PROJECT: Advanced Boiling Water Reactor (ABWR)

SUBJECT: SUMMARY OF MEETING WITH GE ON SEPTEMBER 21-22, 1992

A public meeting was held between the Nuclear Regulatory Commission (NRC) staff, GE Nuclear Energy (GE), and the Nuclear Materials Resources Council (NUMARC) at the offices of GE in San Jose, California, on September 21-22, 1992. The purpose of this meeting was to discuss issues related to the industry and staff review of the ABWR inspections, tests, analyses, and acceptance criteria. Enclosure 1 is a list of those who attended.

Figure 2.6 Human System Interface Design Implementation Process

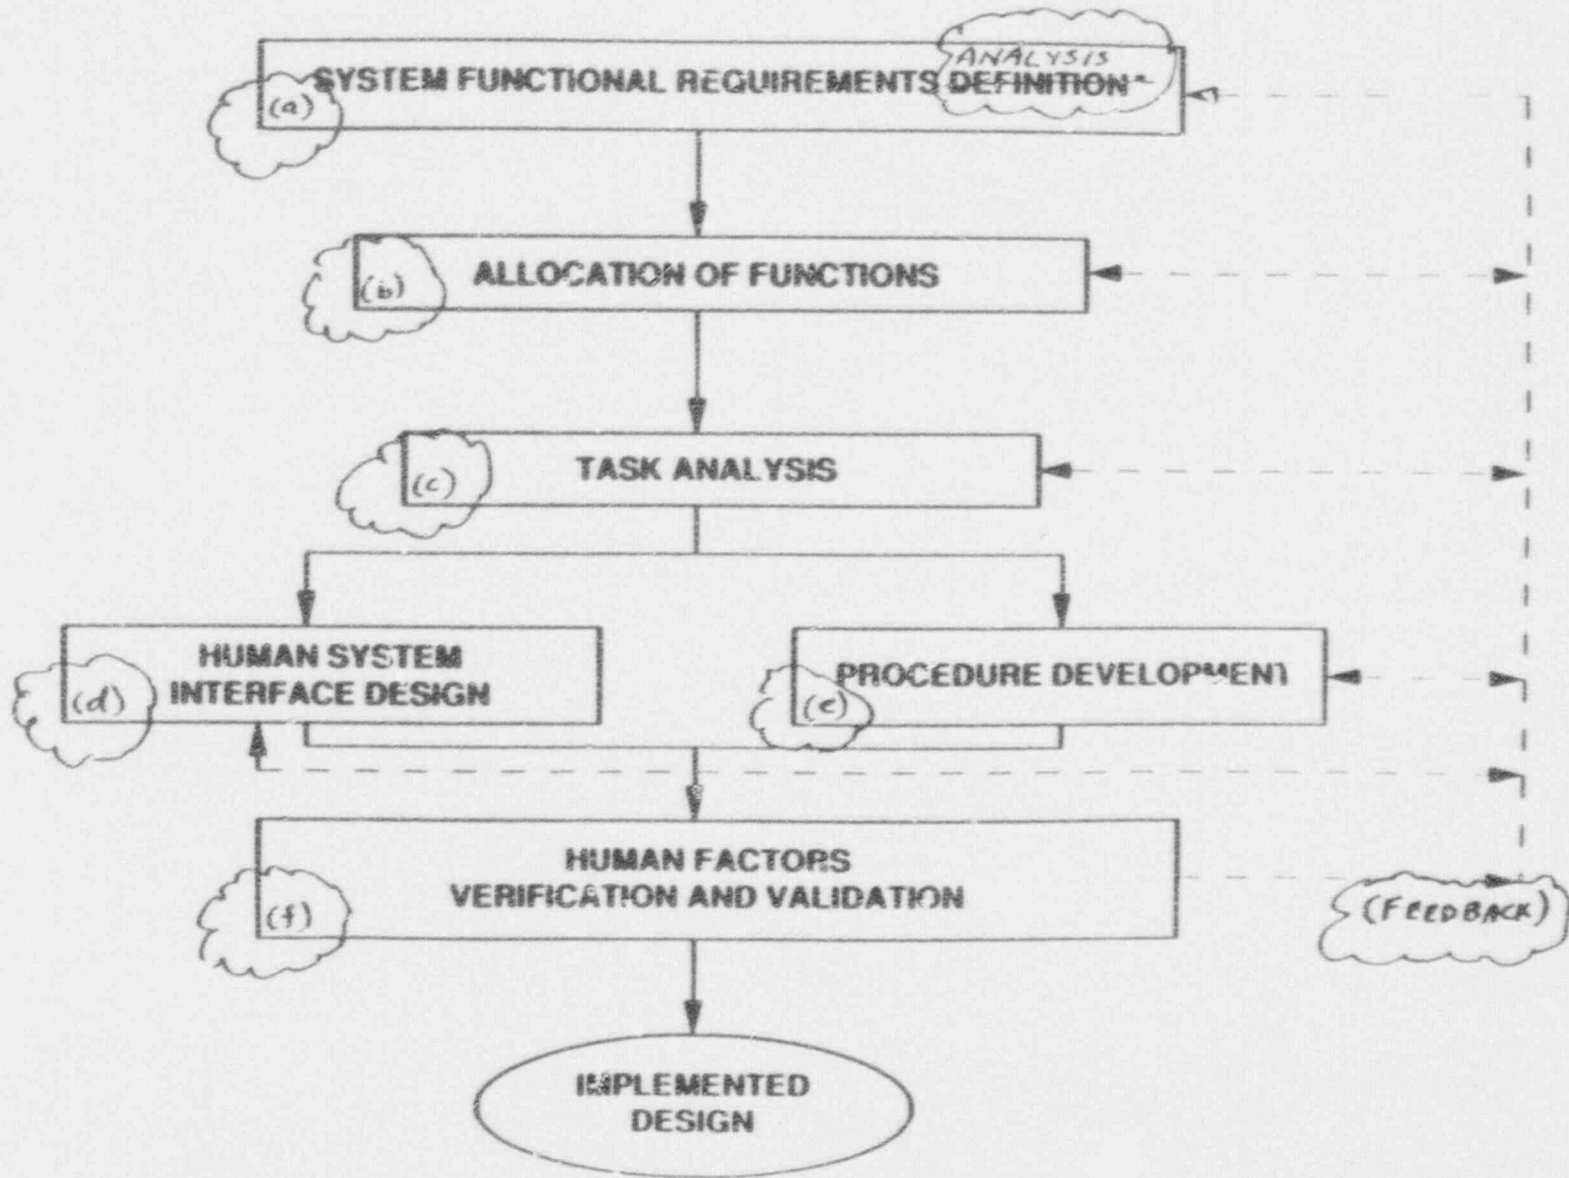
6. **DISAGREE** Each of the reports that will be generated by the applicant should be listed in the "design description."
7. **DISAGREE** a. Figure 3.6.1 should be revised to include the Program Plan and <sup>(a)</sup> <sup>(b)</sup> "definition" should be replaced with "analysis" in the first box.
